Urgent Field Safety Notice (FSN)

Product Name: DePuy ReClaim® Reamer Extension

FSCA-identifier: DVA-107508-HHE

Date: Oct 2014

Figure 2: Redesign RECLAIM® Instrument Tray (2975-50-600) – Note: The swap-out set will contain: 1 #2975-50-600 (empty), 2 #2975-00-500 (redesign distal reamer extensions), and 1 #2976-20-000 (clear out reamer)

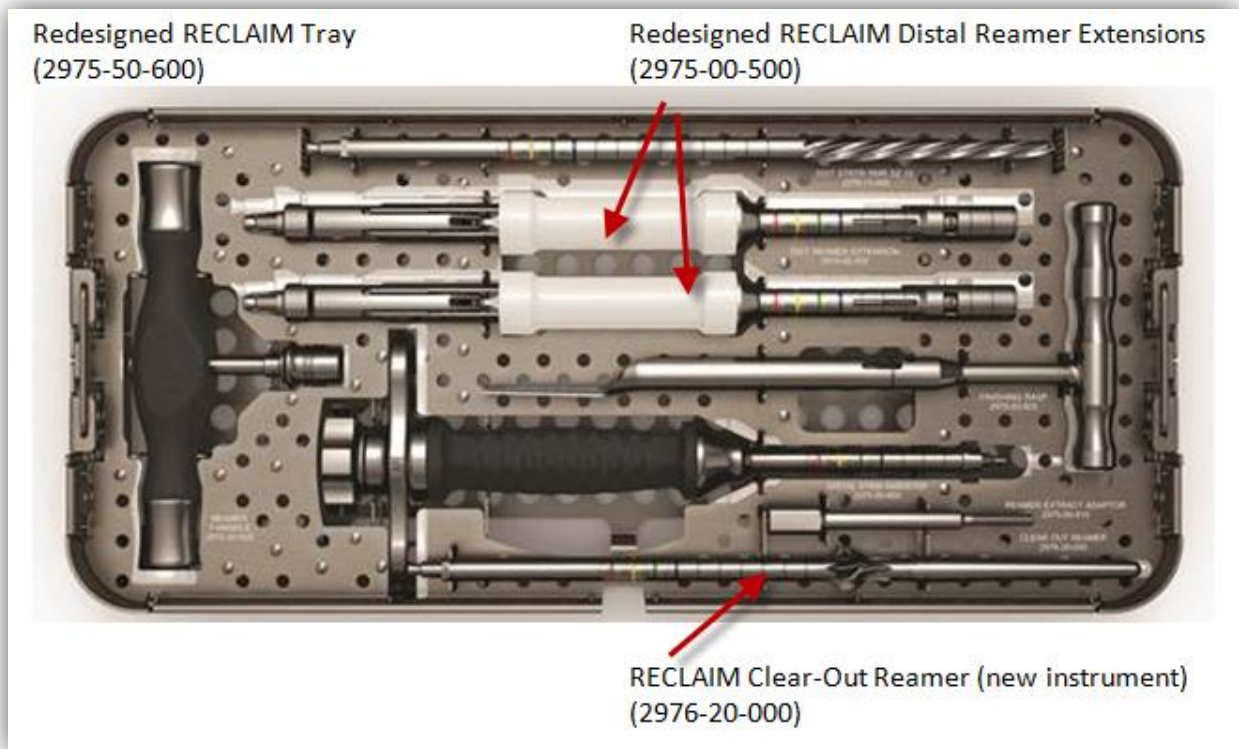
The redesigned instruments include a RECLAIM Clear-Out Reamer (2976-20-000) and an updated RECLAIM Instrument Tray (2975-50-600), which will be included as part of the swap-out set.

The swap-out set will consist of (see Figure 2):

Figure 4: Visual Comparison Between the Redesigned Instrument and Tray and the Affected Instrument and Tray.
NOTE: The part number is the same for the Affected & the Redesigned Distal Reamer Extensions (2975-00-500)

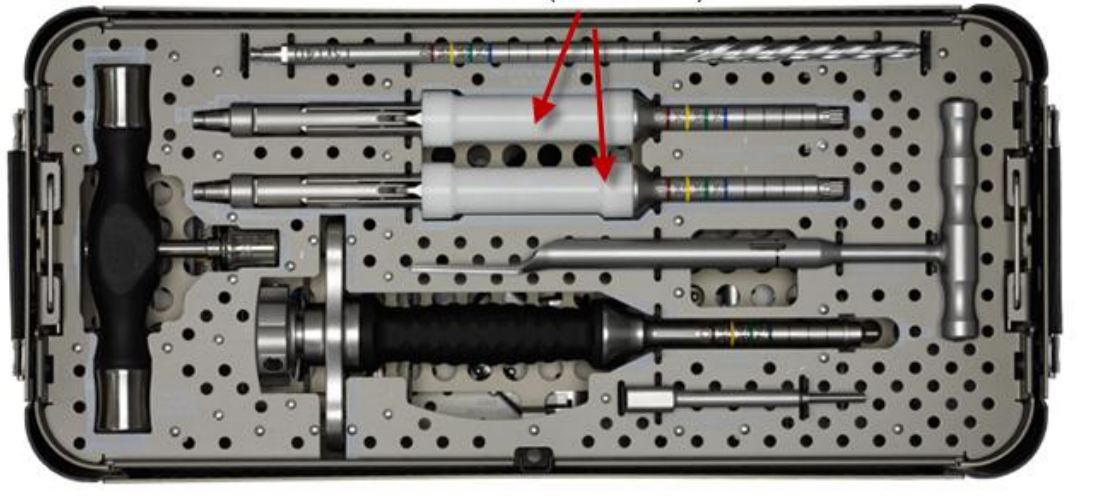
The figure below highlights the redesigned swap-out distal reamer extension instruments, tray, and clear-out reamer compared with the affected instruments and tray:

Figure 5: Visual Comparison Between the Affected RECLAIM Distal Reamer Extension and the Redesigned RECLAIM Distal Reamer Extension
– NOTE: The part number is the same for the Affected & the Redesigned Distal Reamer Extensions (2975-00-500)

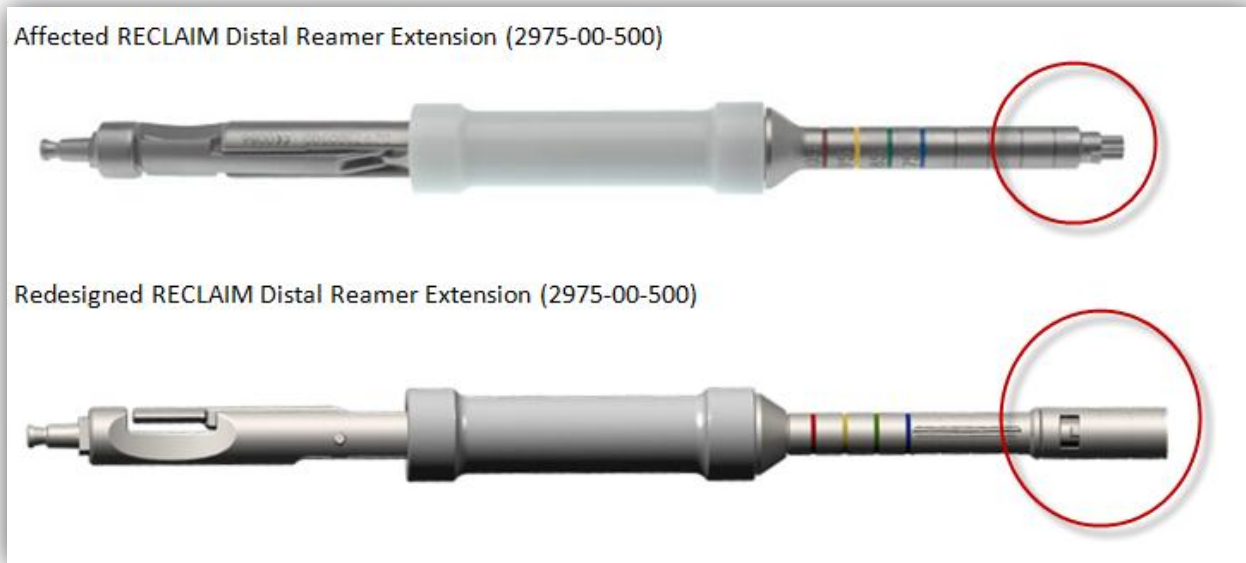
In March 2013, DePuy Orthopaedics, Inc. issued a voluntary device correction for the RECLAIM® Distal Reamer Extension (2975-00-500) due to the potential for one or both of the tabs on the original design to break off and potentially be left in the patient. The RECLAIM® Distal Reamer Extension has been redesigned, and the company is formally swapping out the affected instruments.

The image below compares the affected distal reamer extension with the redesigned distal reamer extension:
